**CITY OF MILWAUKIE
PLANNING COMMISSION
MINUTES
Milwaukie City Hall
10722 SE Main Street
TUESDAY, May 11, 2010
6:30 PM**

5.1 Summary: Riverfront Park
Applicant/Owner: City of Milwaukie
File: DR-09-01, TPR-09-03, WG-09-01, WQR-09-01, and VR-09-03
Staff Person: Ryan Marquardt

Milwaukie Riverfront Park

Drawing File: P:\V\MAEX0000018\0400CAD\DWG\Sheet\Permit Drawings\DESIGN REVIEW PACKAGE\Fig Existing\Site_MAE00018.dwg Date/Time: Feb 06, 2010 - 8:33am User: bar

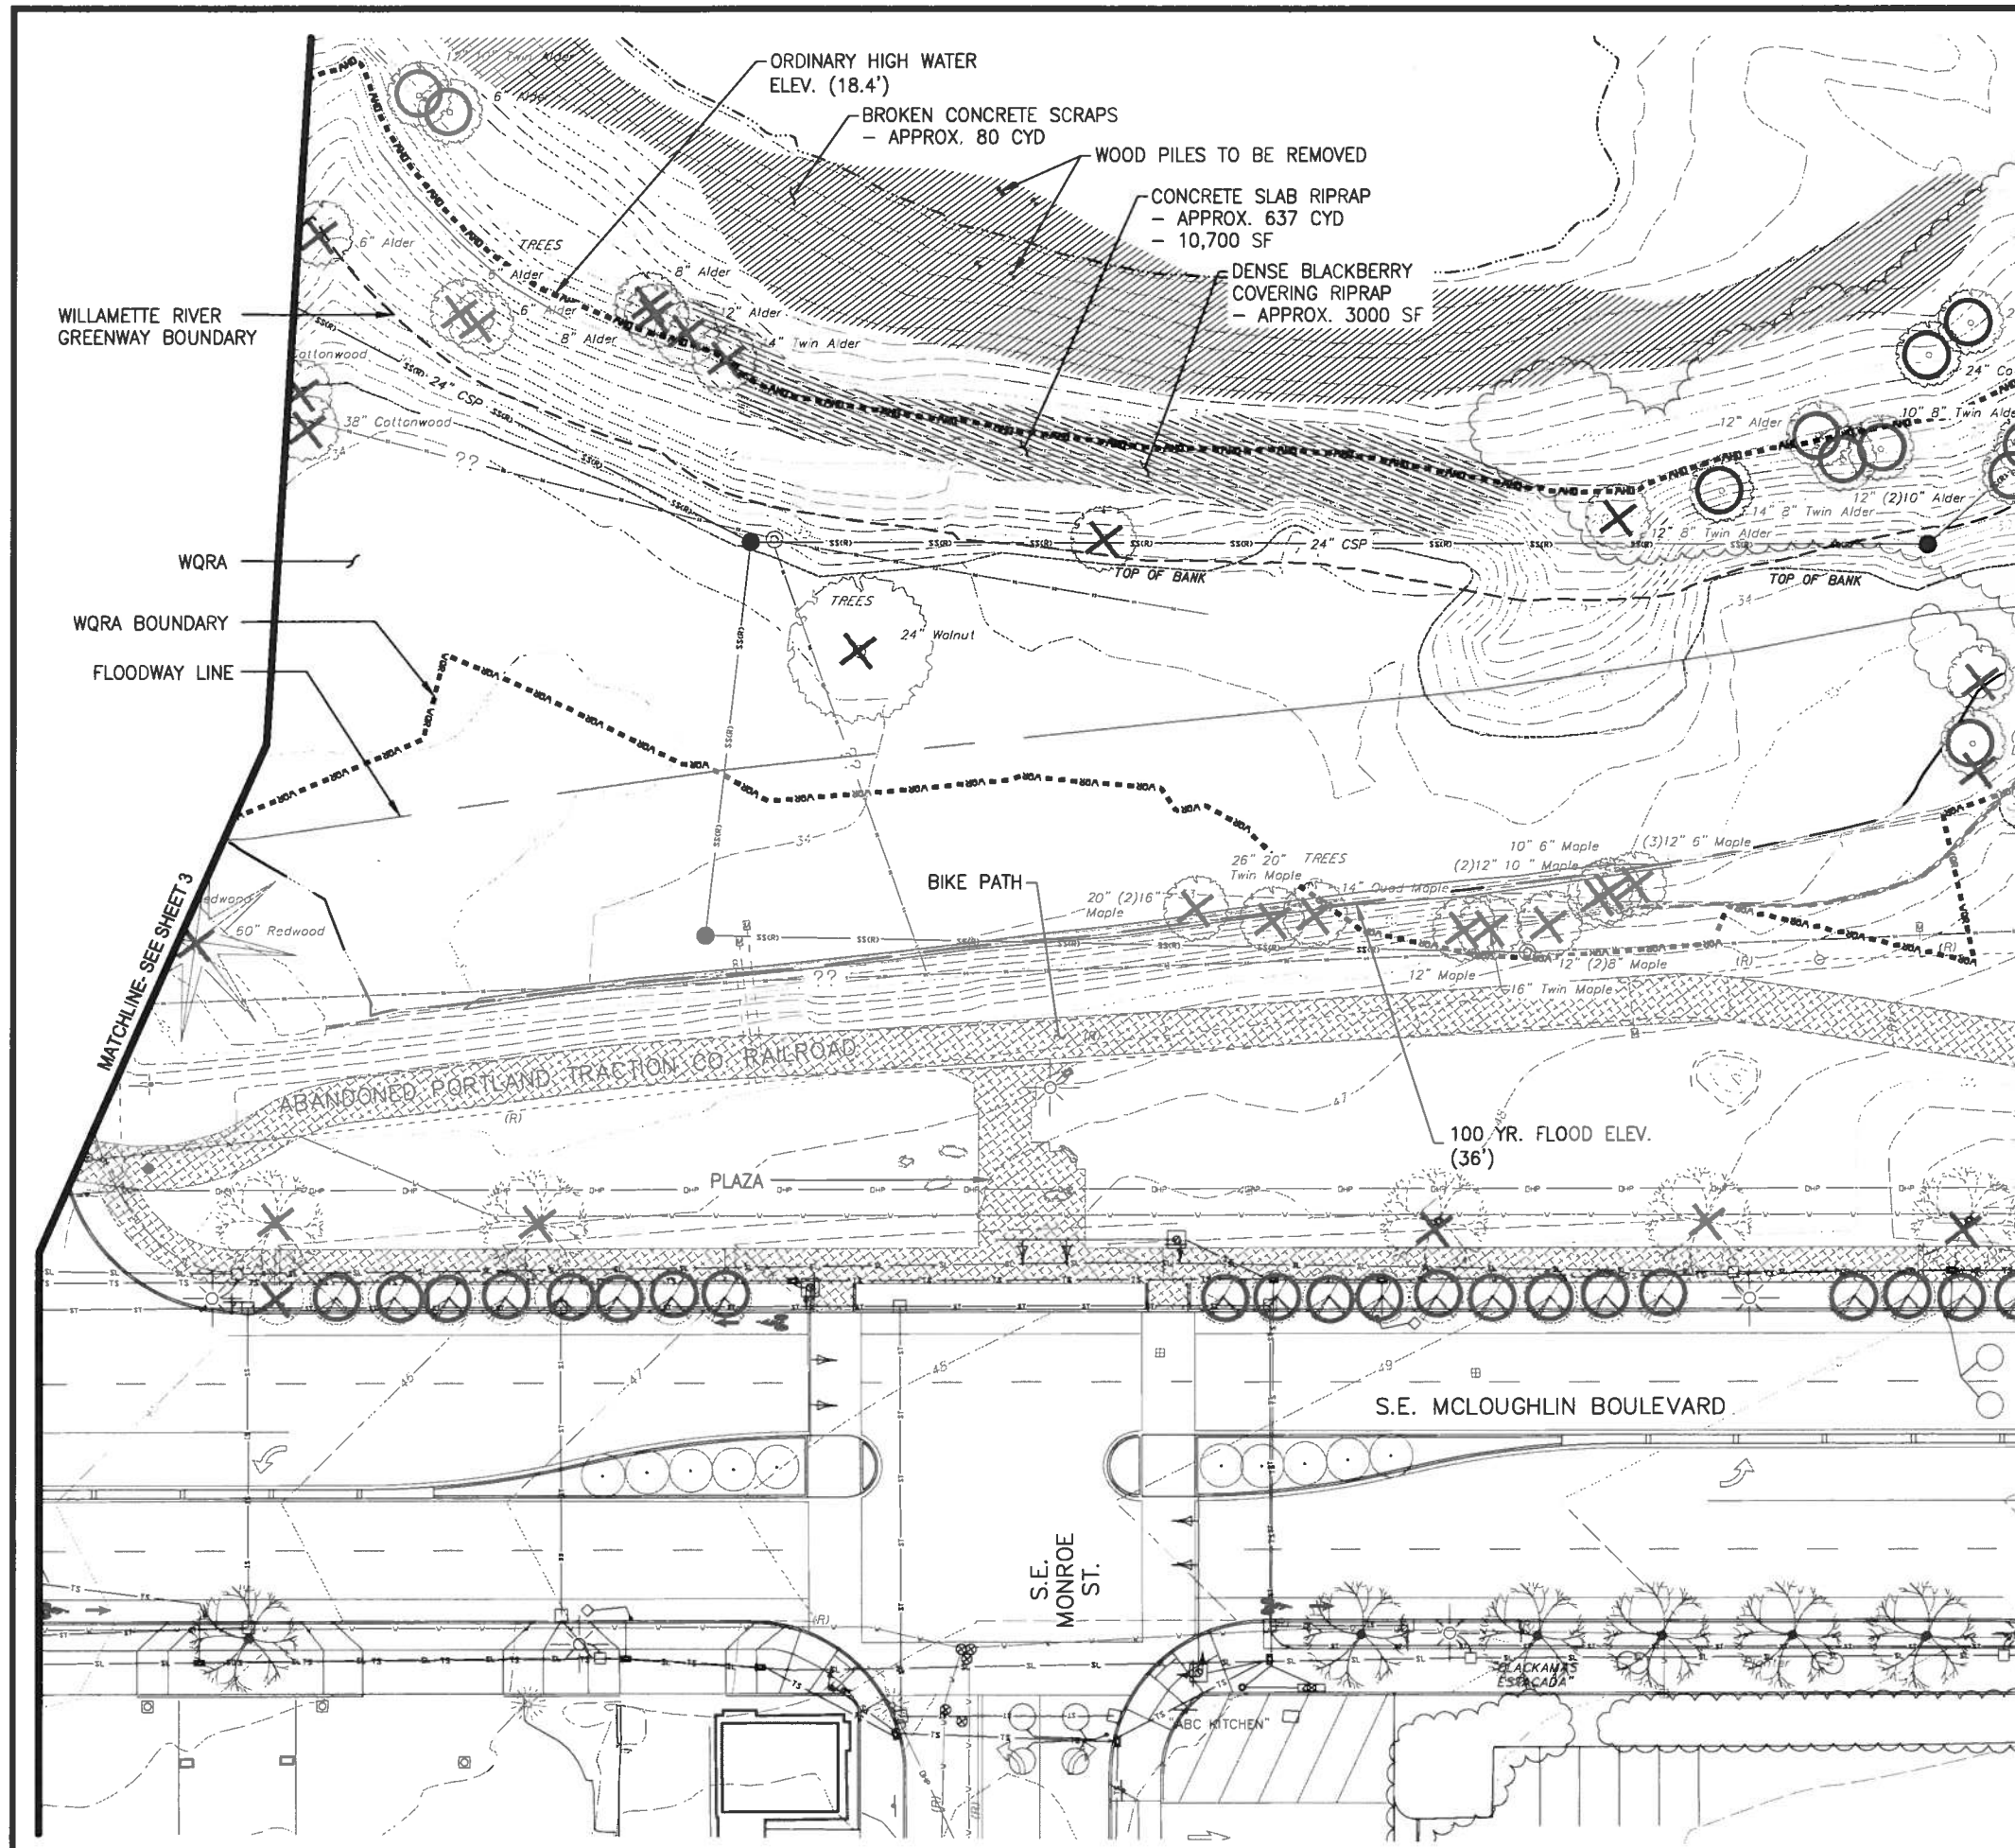
- B. The application is lacking a figure that shows the WQRA boundaries along with all existing natural features. Figure 11 in Tab “B” of the application shows the WQRA boundaries but not all existing natural features. Vegetation communities are only vaguely located on Figure 2 of the 2004 Natural Resource Assessment (NRA; Tab “F”) and WQRA boundaries are only generally sketched in. An overlay of the WQRA boundaries on an aerial photo would be helpful (such as on Figure 2 in the BA, Tab “F”).

- A. Sufficiently addressed in the initial application.
- B. Revised Figures 1, 1A – 1D sufficiently address comments provided regarding this requirement.
- C. Sufficiently addressed in the initial application.
- D. Revised Figures 1, 1A – 1D sufficiently address comments provided regarding this requirement.

Fig 2C
JOB NO. MAEX00000018

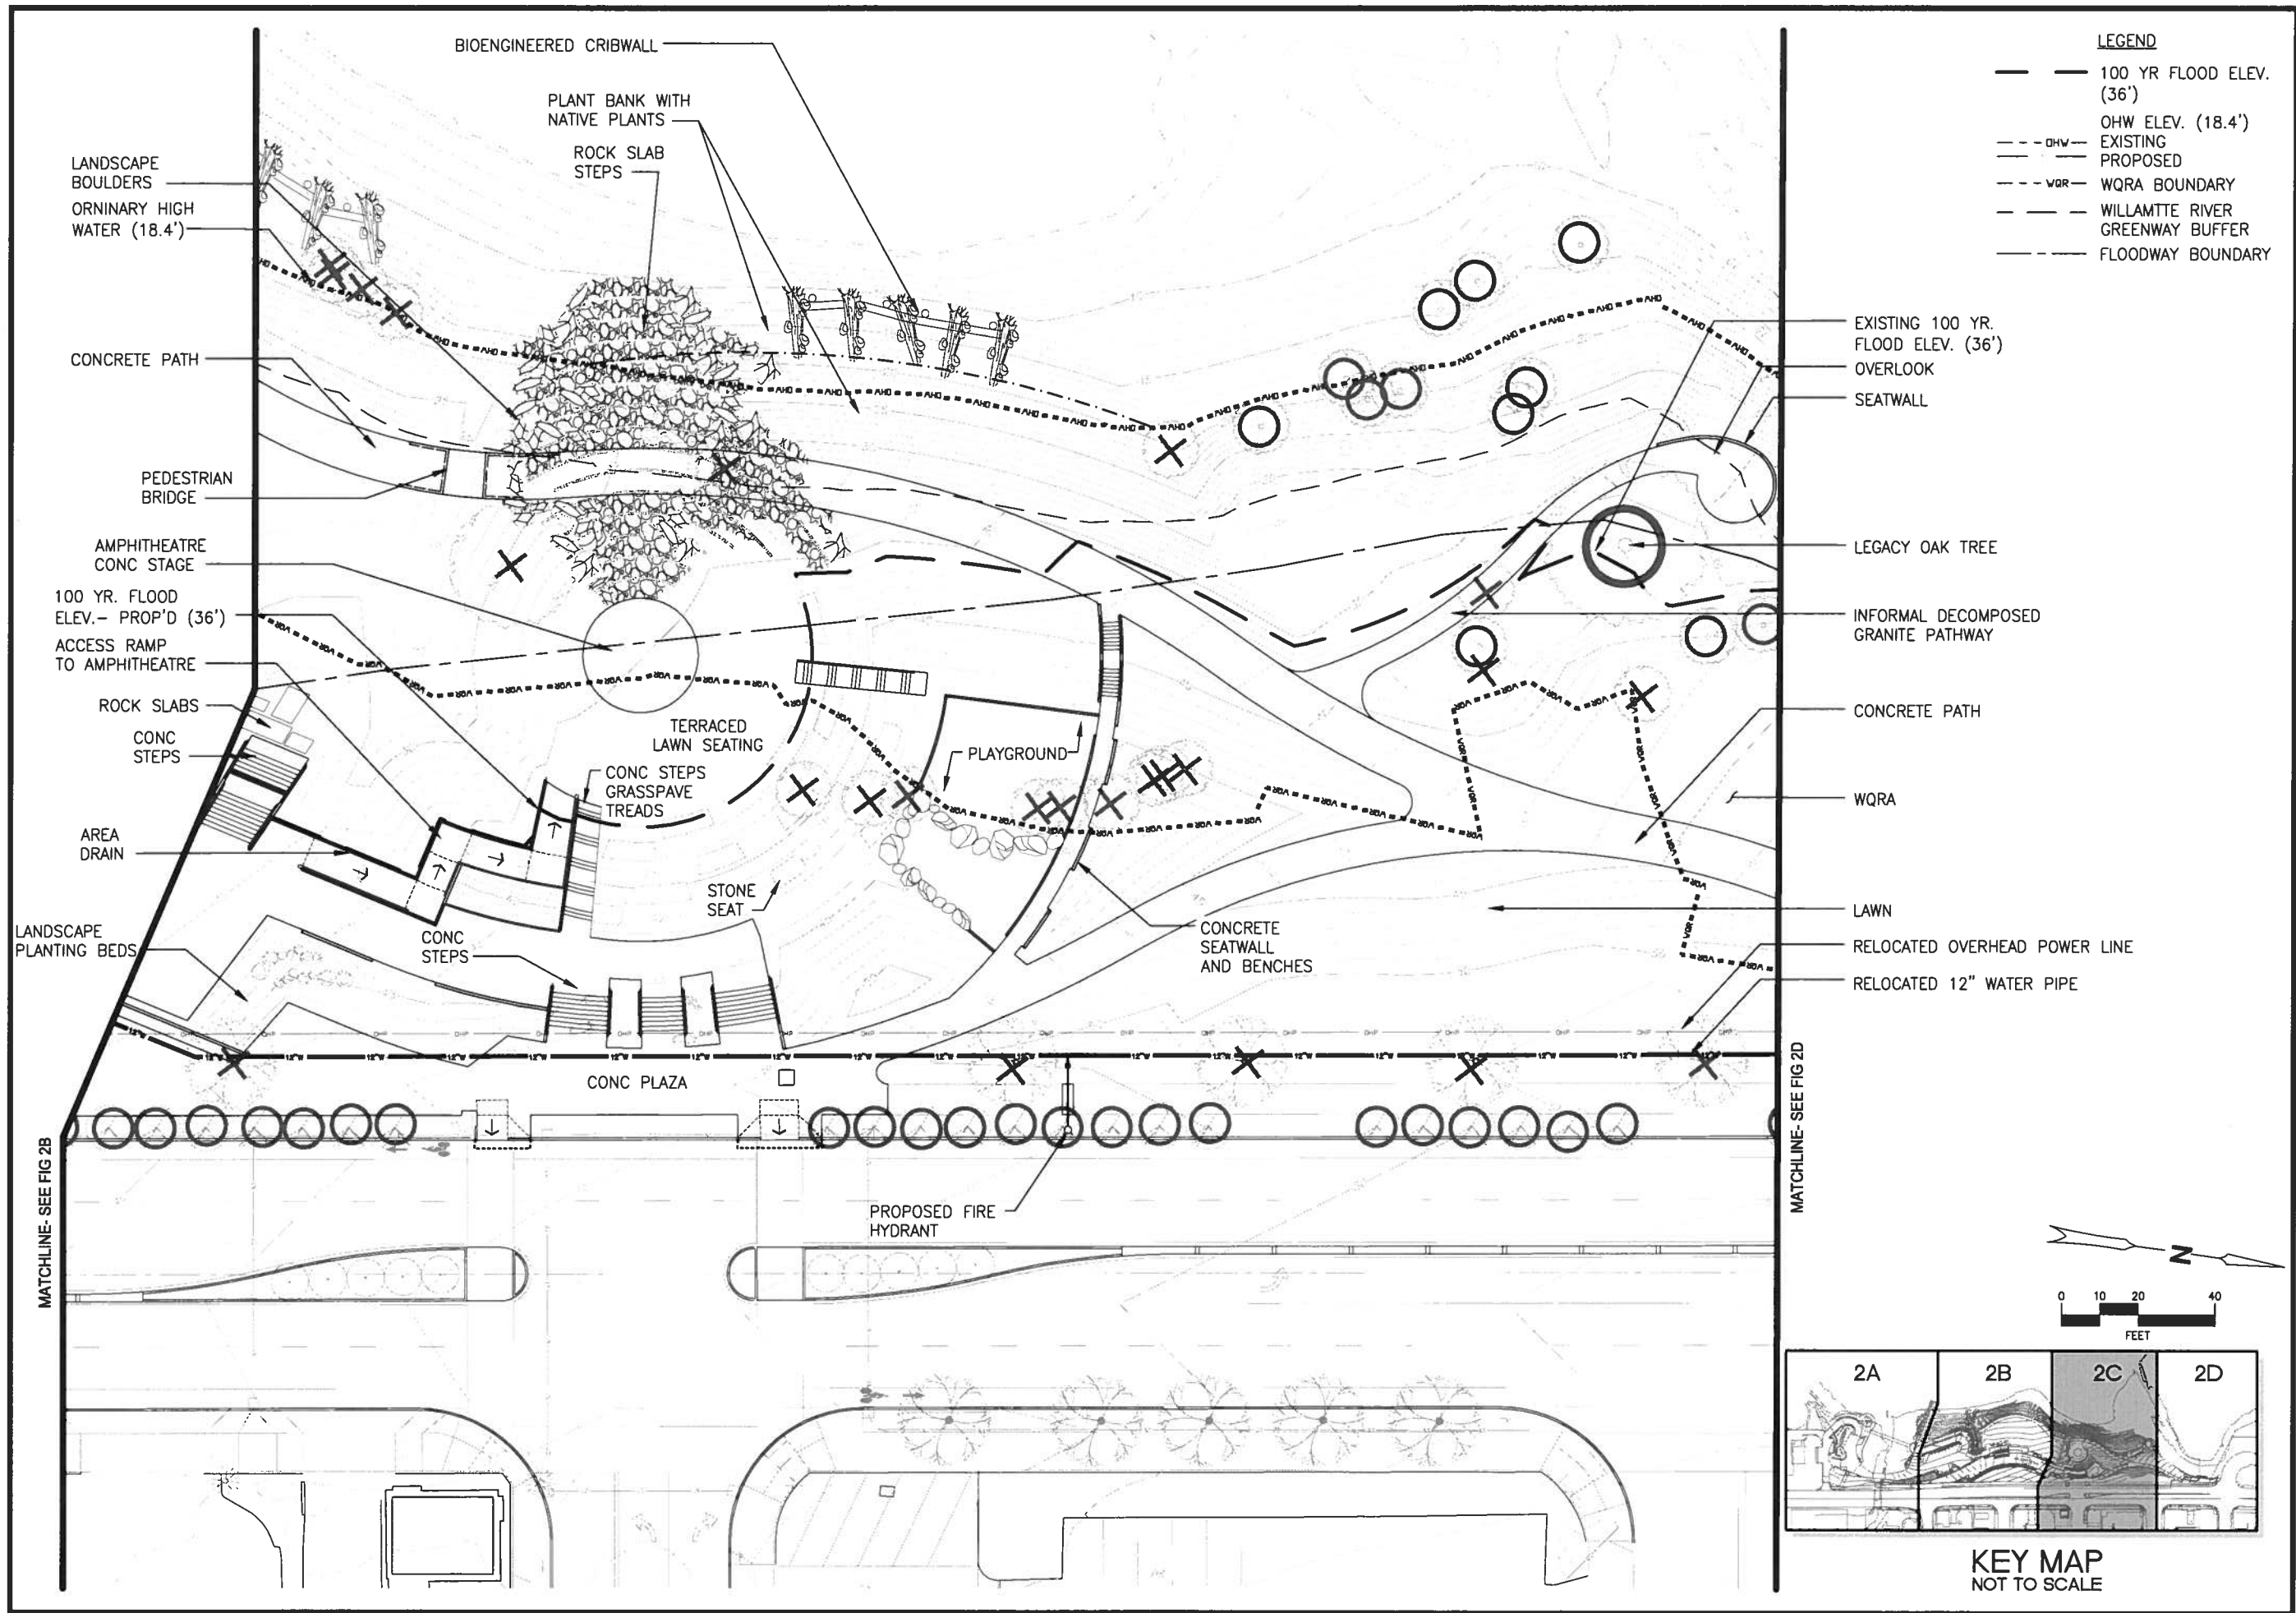
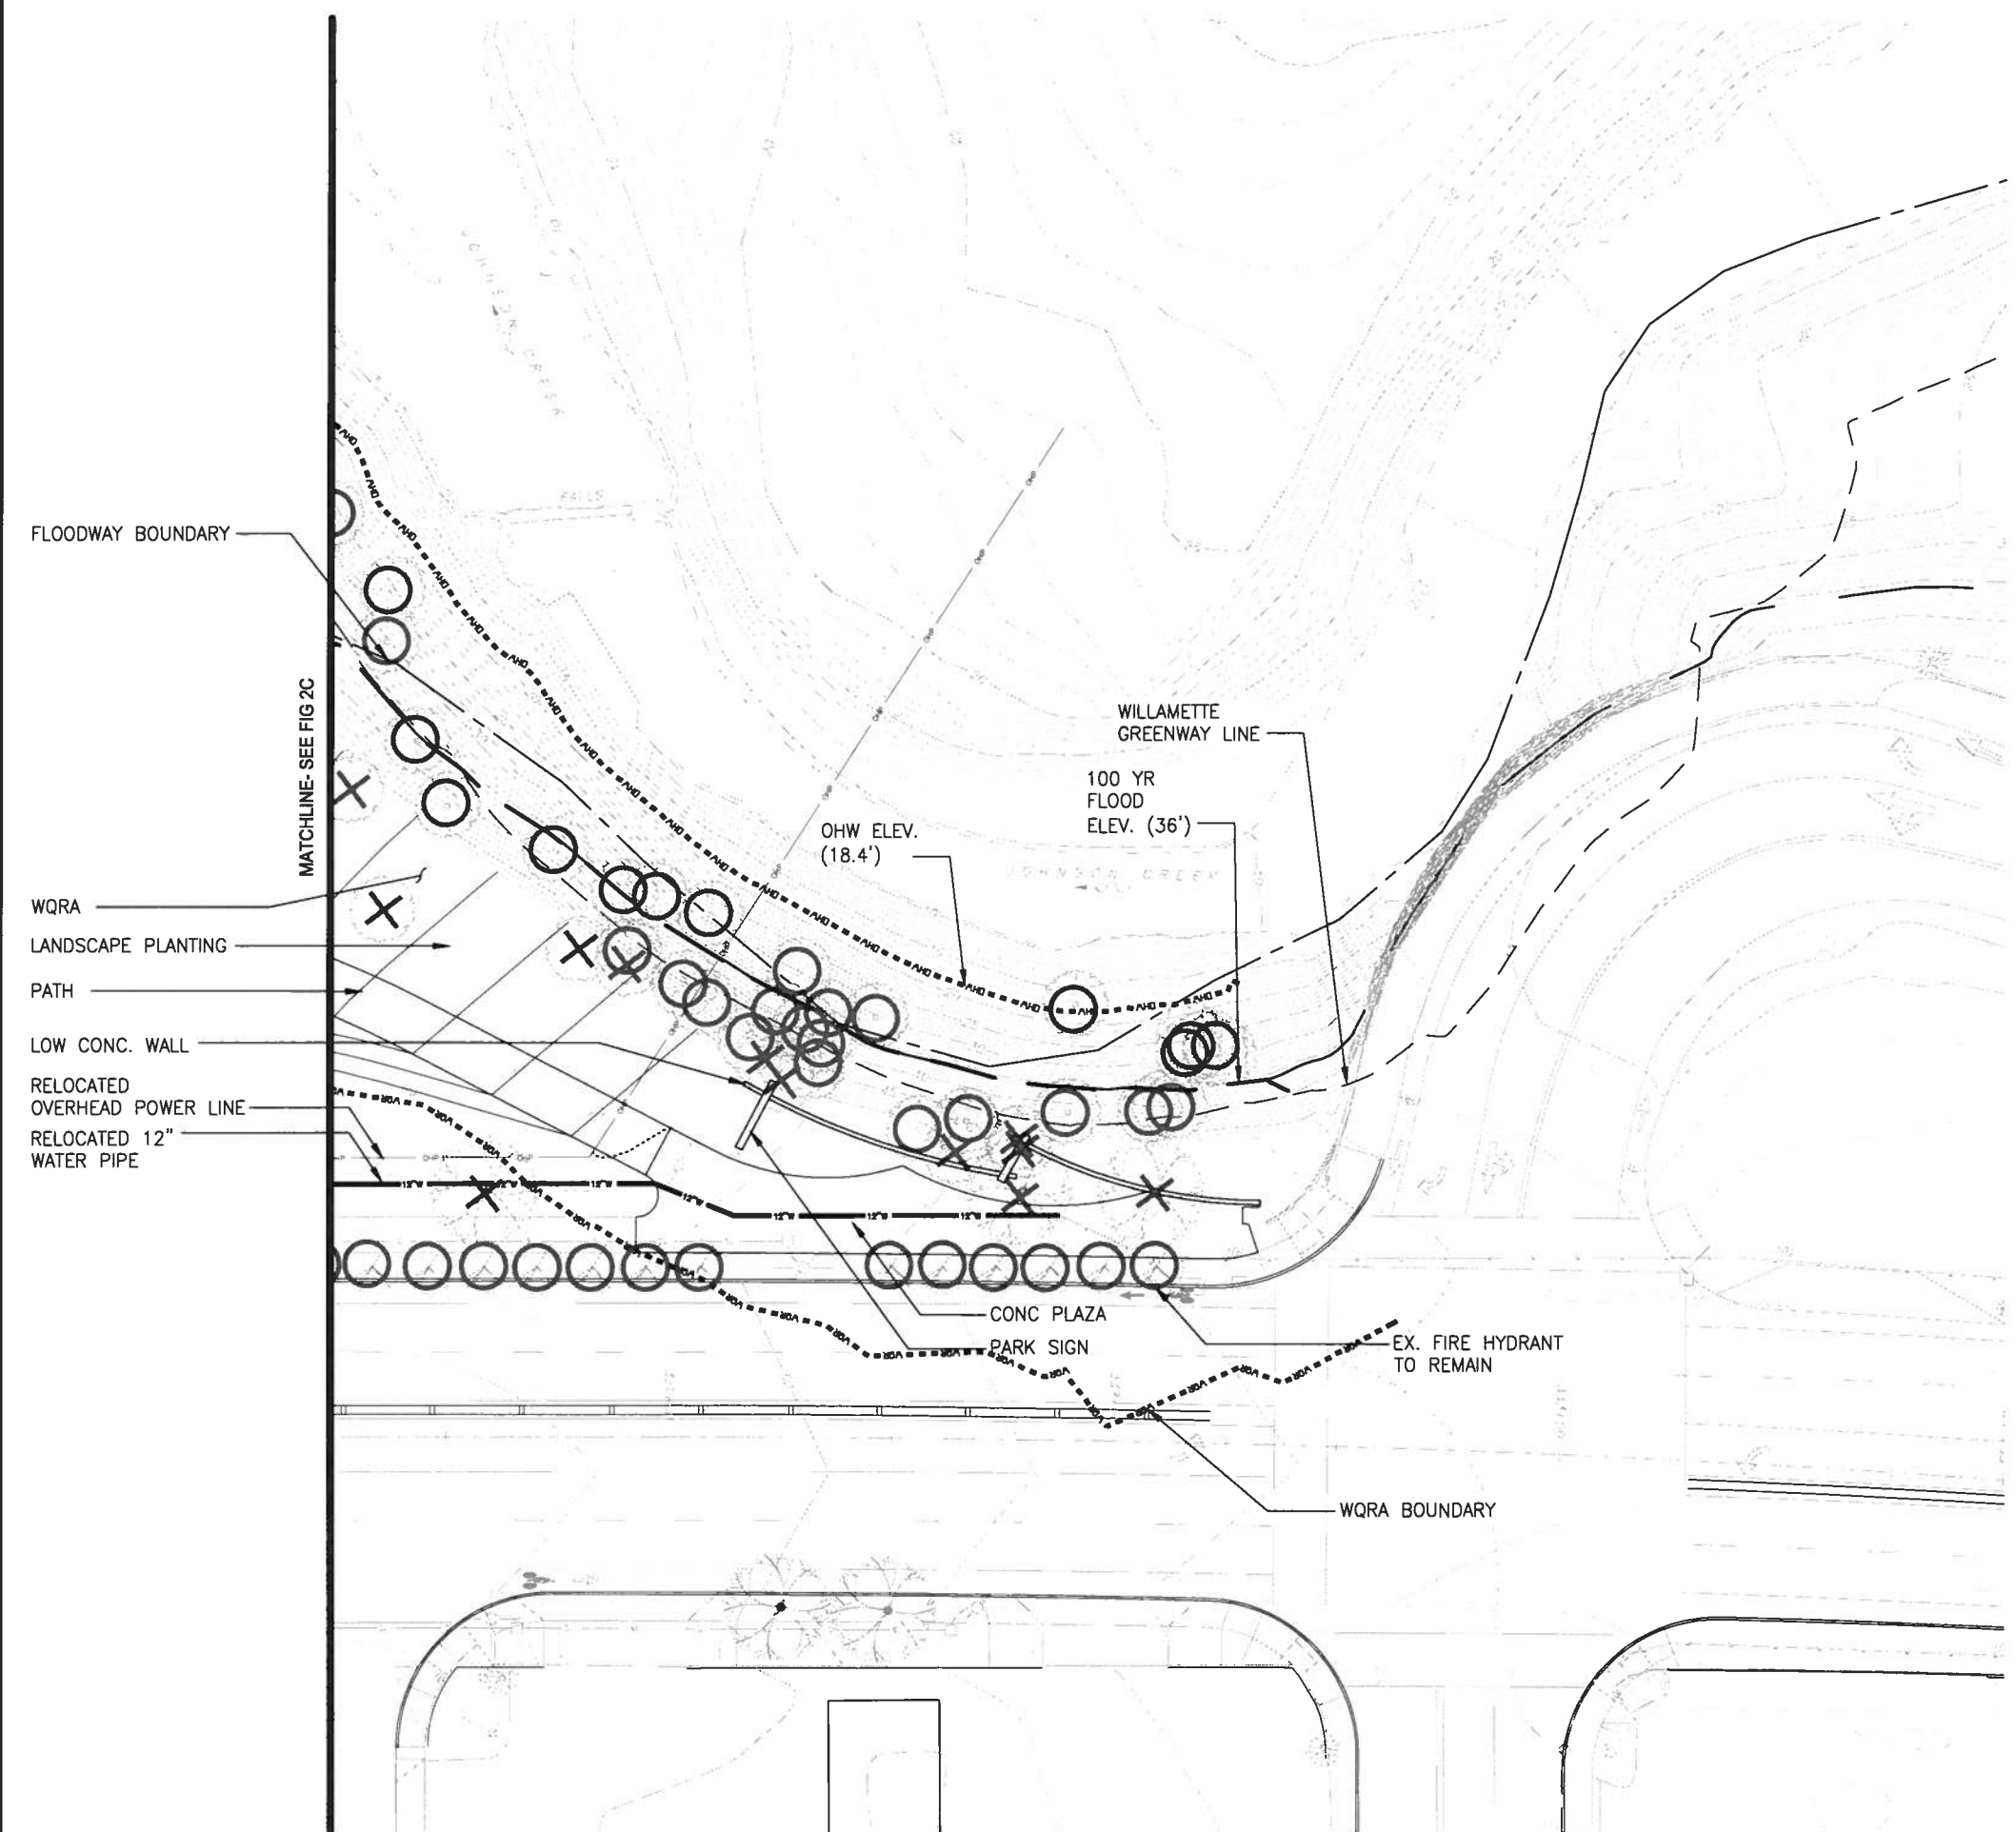
- **Ms. Mangle** responded that the current FEMA flood line was about the same as the 1996 flood line. The City's WQR map used both the FEMA and 1996 flood lines, which did not make a difference in this stretch along the Willamette River. The FEMA 100-year floodplain line was shown on the most recent version of the Park Plan Existing Conditions Maps on page 101 of the Municipal Zoning Code. Figure 2D of the supplemental packet showed a 100-year flood elevation. [also Figures 2, 2A-2C]
